SERVICE BULLETIN NO: PC7-A73-002

ATA CHAPTER: 73

POWER CONTROL SUPPORTING STRUT ASSEMBLY - CRACKING

Power Control Supporting Strut - Inspection
Figure 1

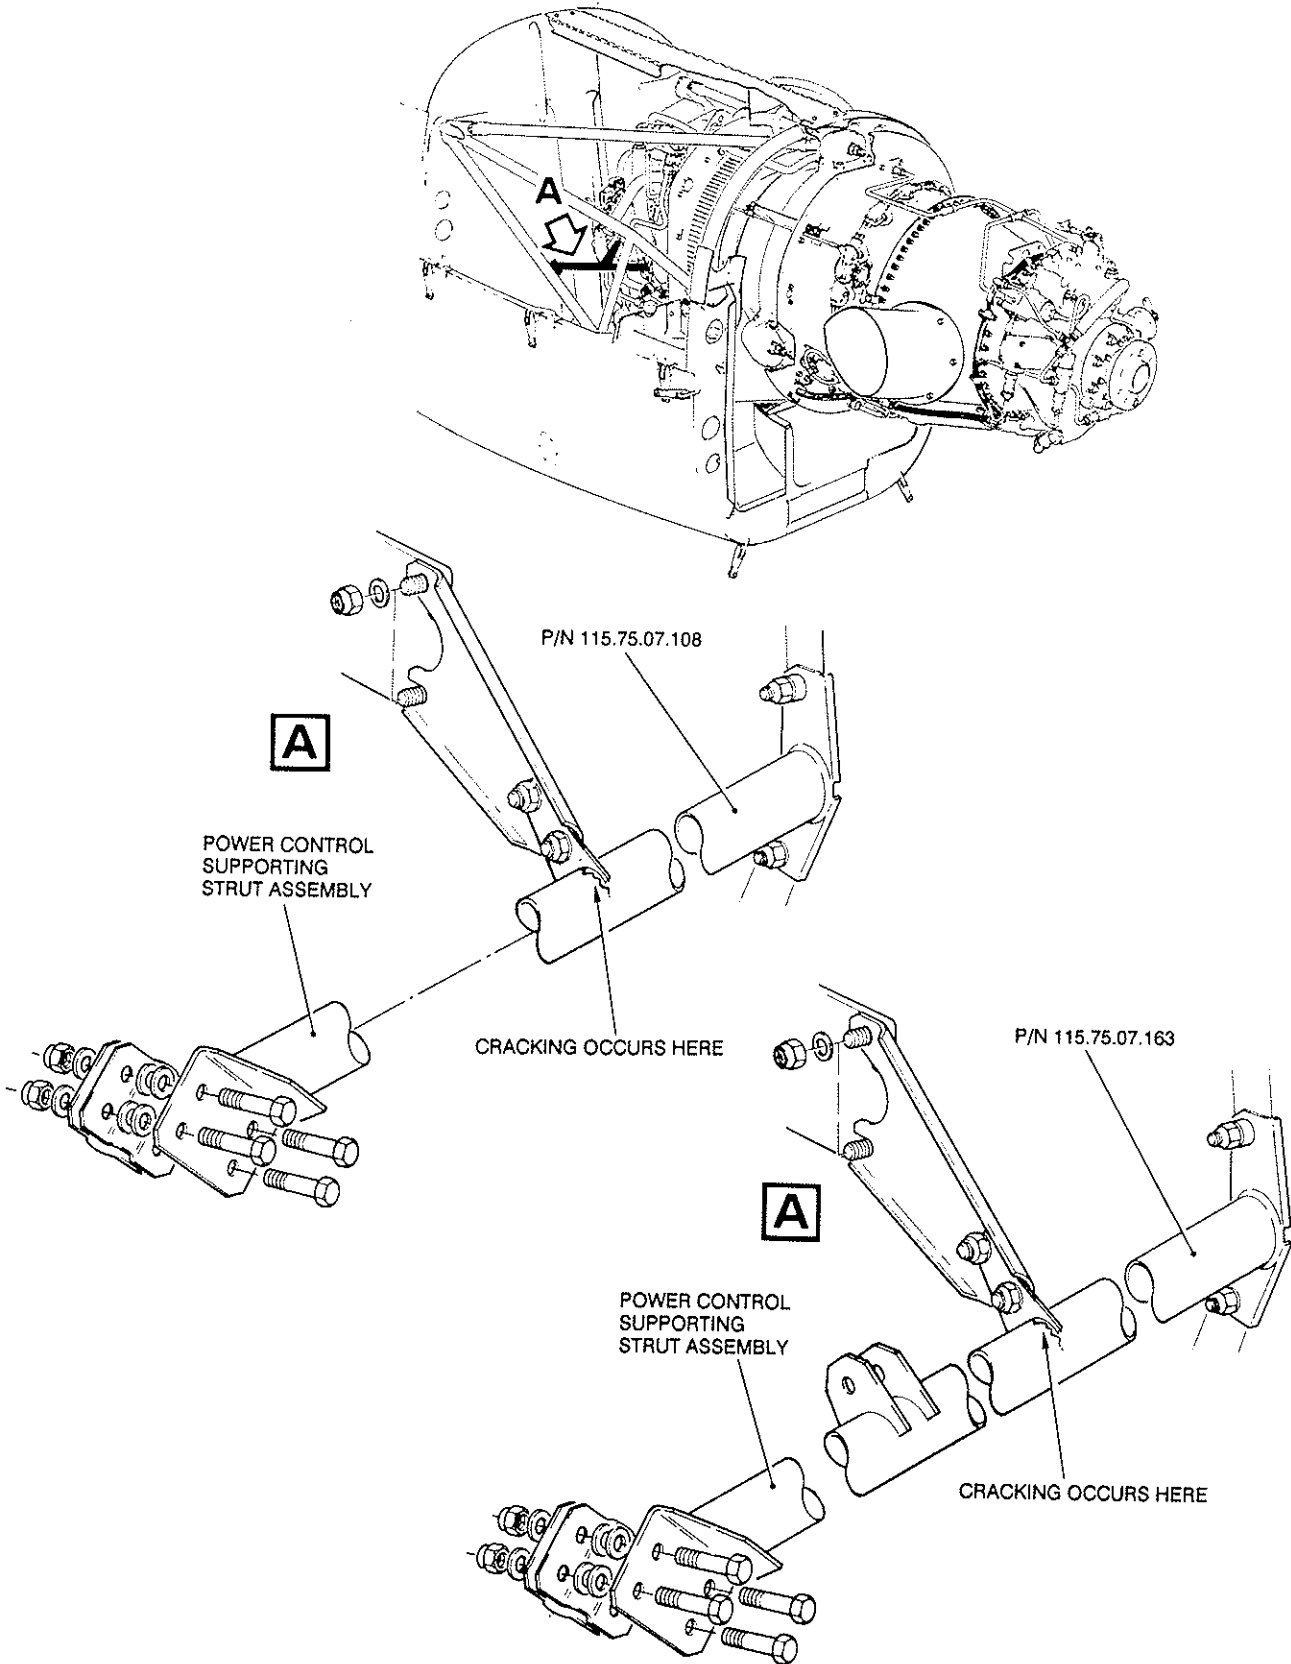
Fatigue cracks have been found on some Power Control Supporting Struts. The struts were cracked at the weld on the HP fuel pump support attachment lug and radially around the strut tube.

- (1) Inspect the weld and the tube structure around the weld for cracks. Use a torch and mirror. - If cracks are found, SB 73-003 must be incorporated before the next flight.

- (i) If no cracks were found during the inspection procedure, repeat the accomplishment instructions of this SB after every 100 flying hours.
- (ii) If a crack is found during the inspection procedure the aircraft must be modified to SB 73-003 standard.
